Harwich Planning Board Agenda
Tuesday, April 13, 2021 – 6:30 PM
Town Hall, 732 Main Street, Harwich

Planning Board Agenda Item II.A.
For April 13, 2021
Limited Staff Report
PB2020-28 Cape Cod Oil

PB2020-28 Cape Cod Oil Company, H. Tasha, TR. of M.J.T. Enterprises, as applicant, Jacobs Driscoll Engineering, Inc., as representative, seeks approval of a Site Plan Review Special Permit to establish and install two (2) 30,000 gallon propane tanks along with appurtenant equipment fixtures and site features pertinent to the establishment of a new Heating Fuel Resale and Storage use, which is an allowable use within the zoning district. The application is pursuant to the Code of the Town of Harwich §325-55. The property is located at 6 Station Avenue, Map 39, Parcel K3, in I-L zoning district.

Site Development Plans Propane Distribution Facility

EXISTING CONDITIONS PLAN

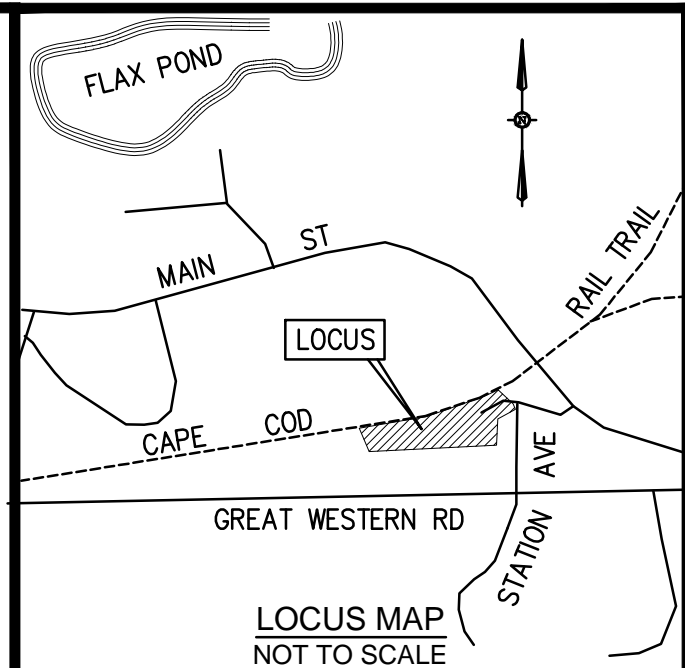
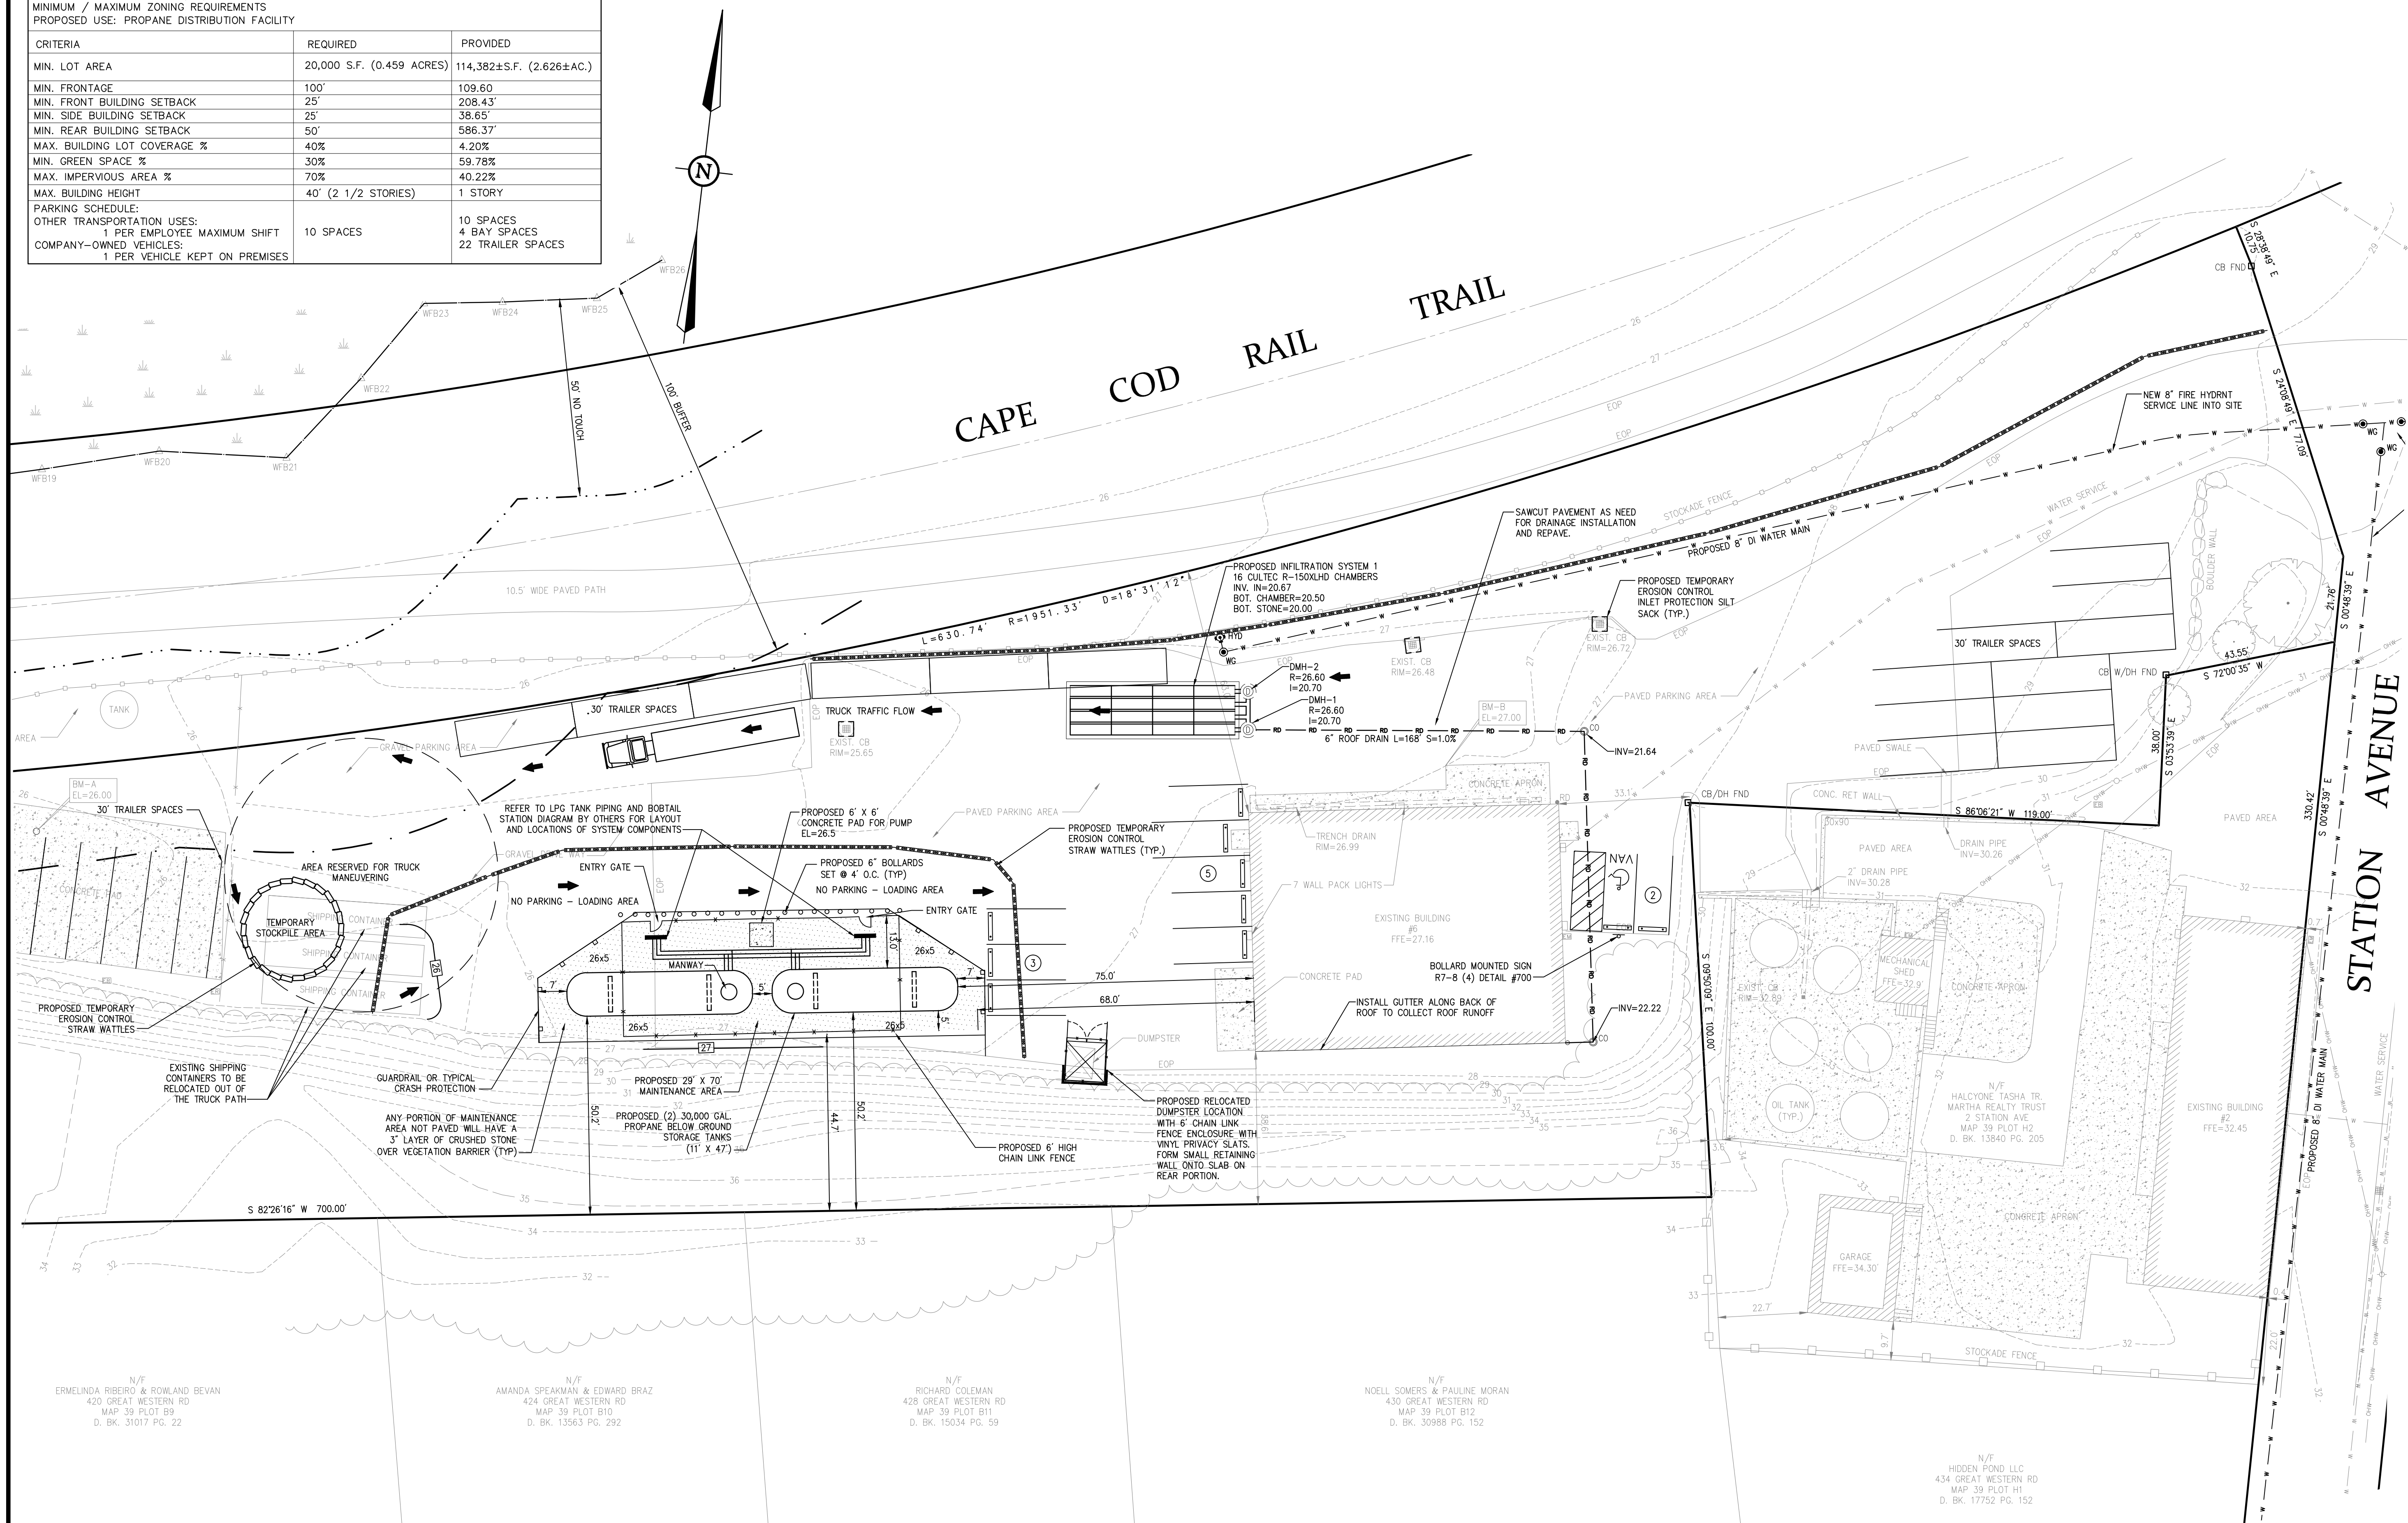
There are three shipping containers and a shed shown on the existing conditions plan. Uses for these items should be determined, particularly the containers if they are to be relocated. If relocated, the plan and approval shall be incorporated into the findings and decision. This may require re-examining the parking schedule.

U/G 30,000 GWC TANKS
SIDE VIEW CROSS SECTION DETAIL
SCALE: NONE

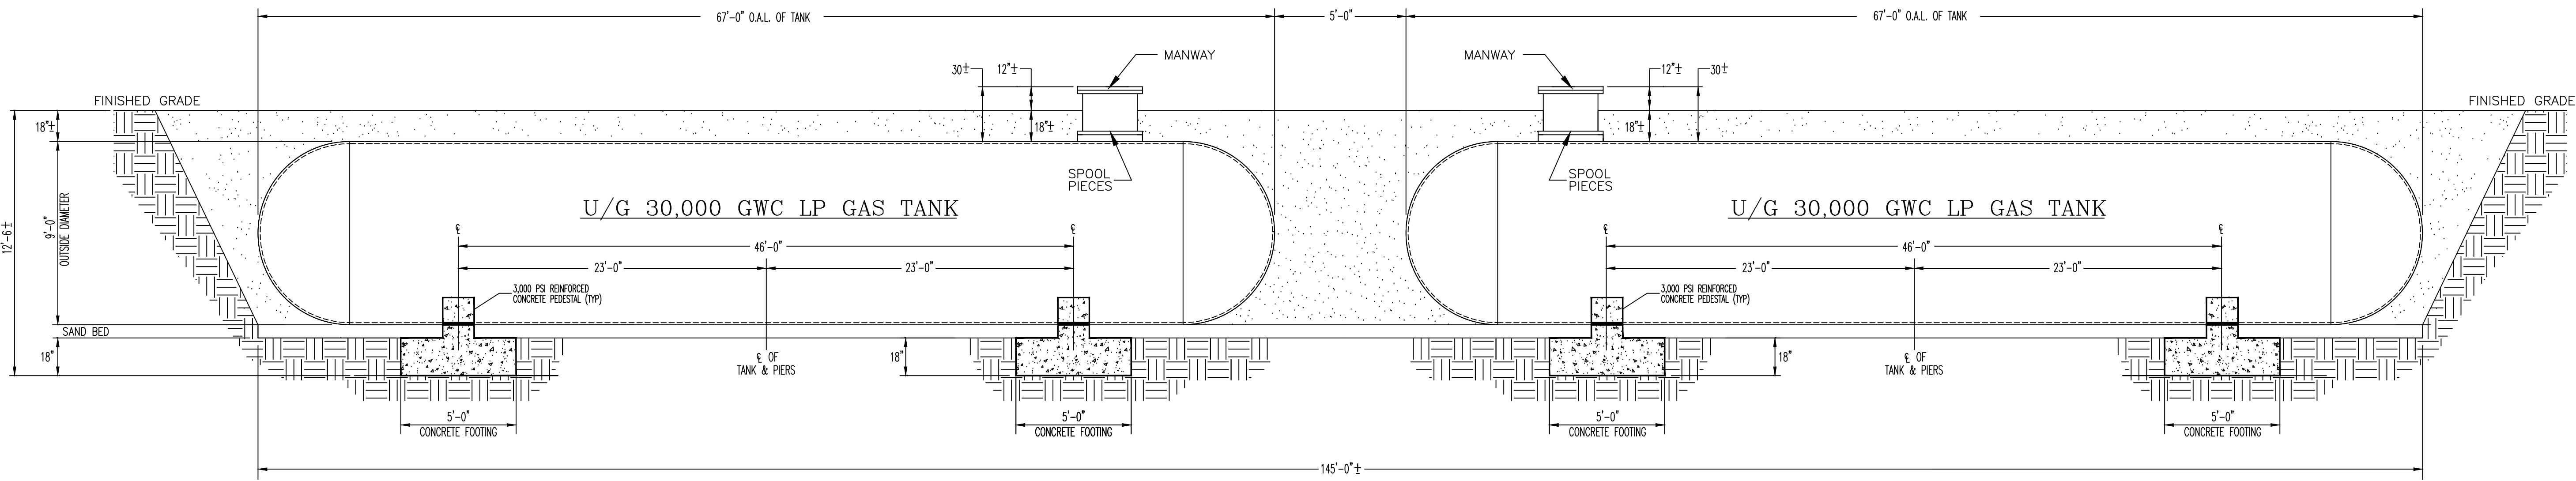
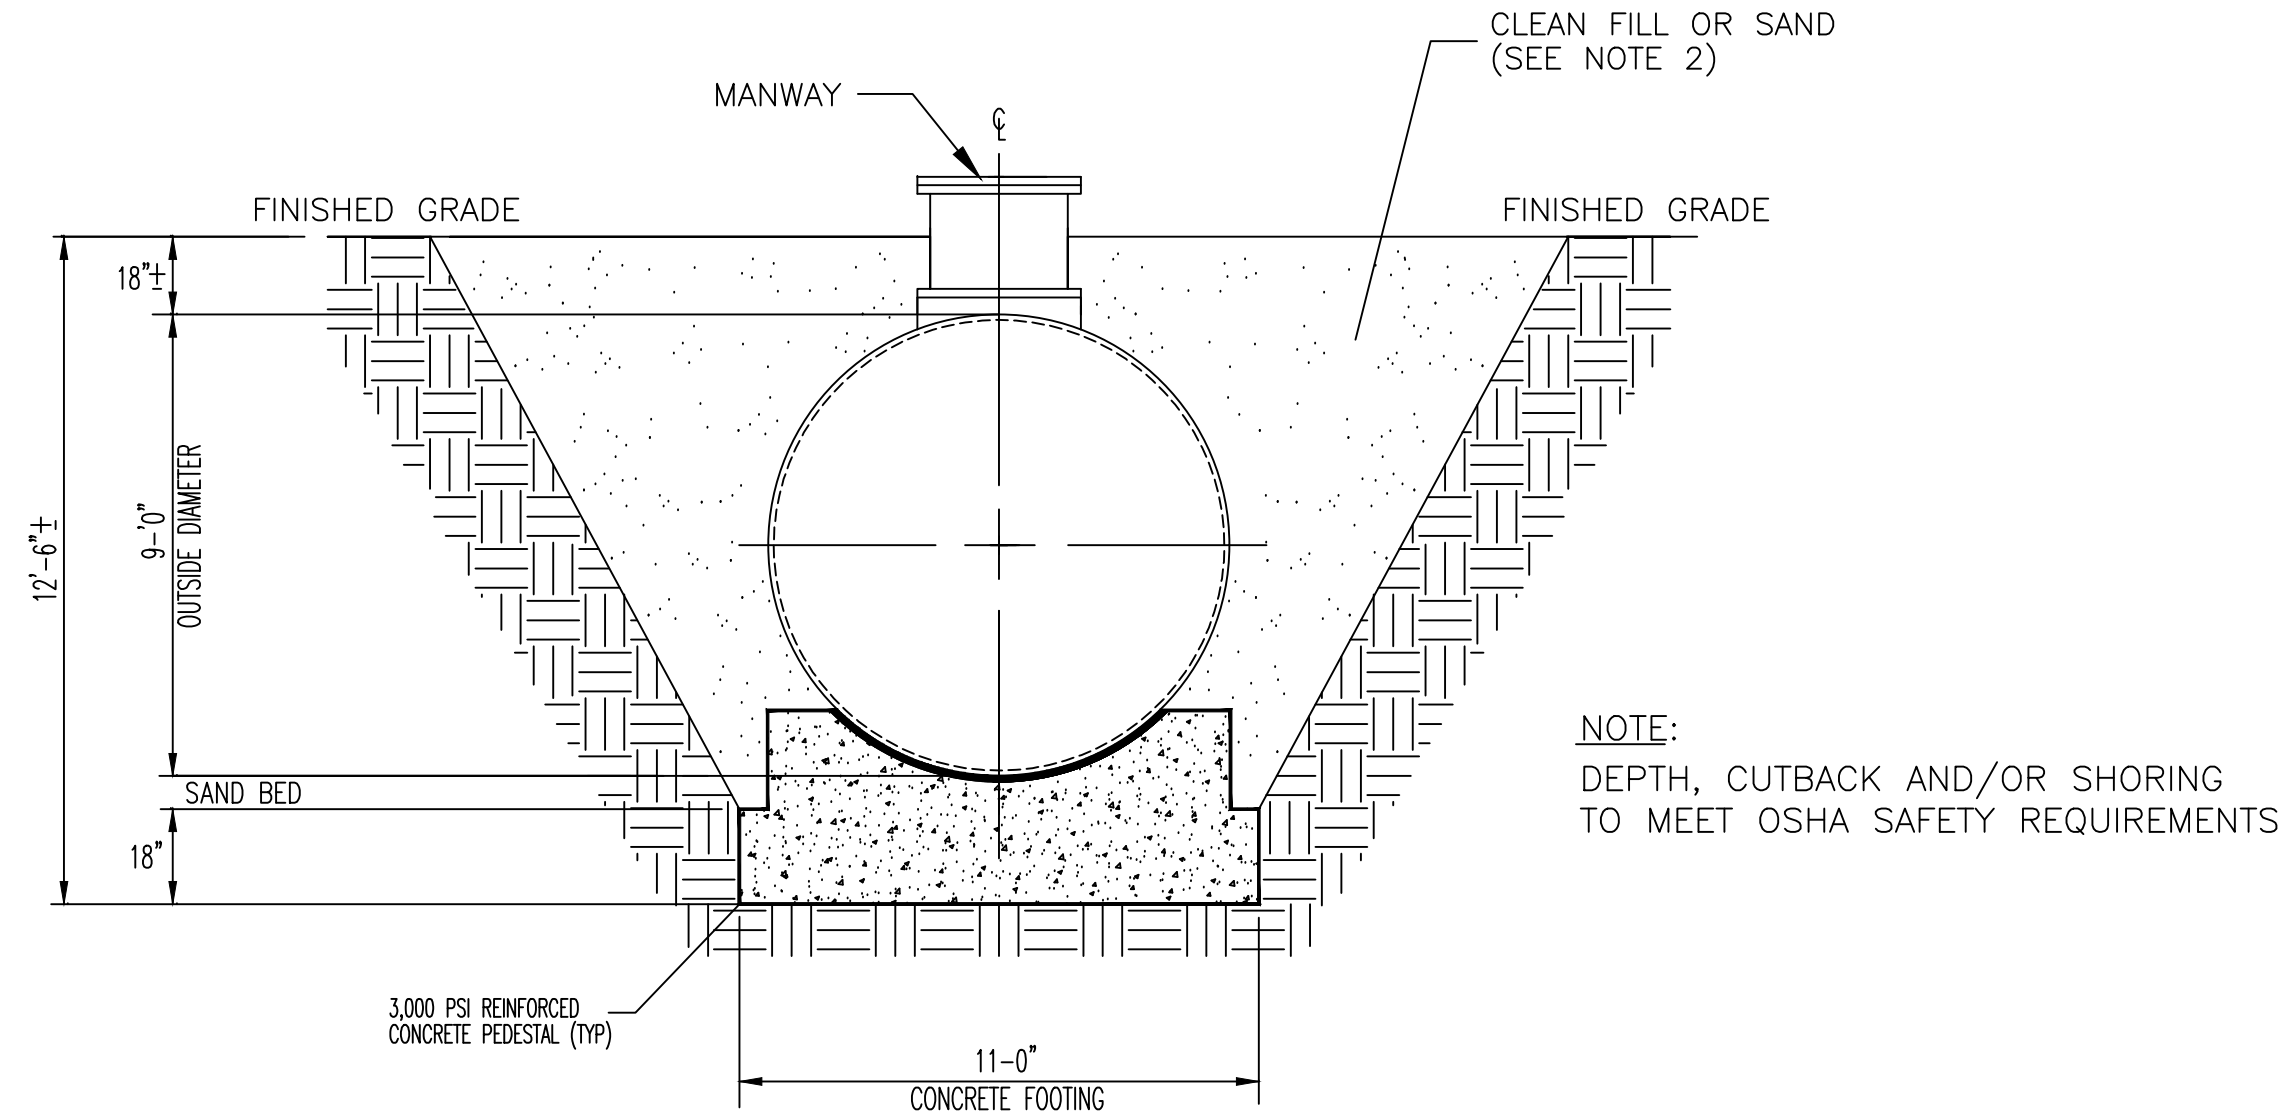
- Please further describe the tank size. The drawings in the package show 44’X11’. Assuming these are length and width, what is the height of the tanks?
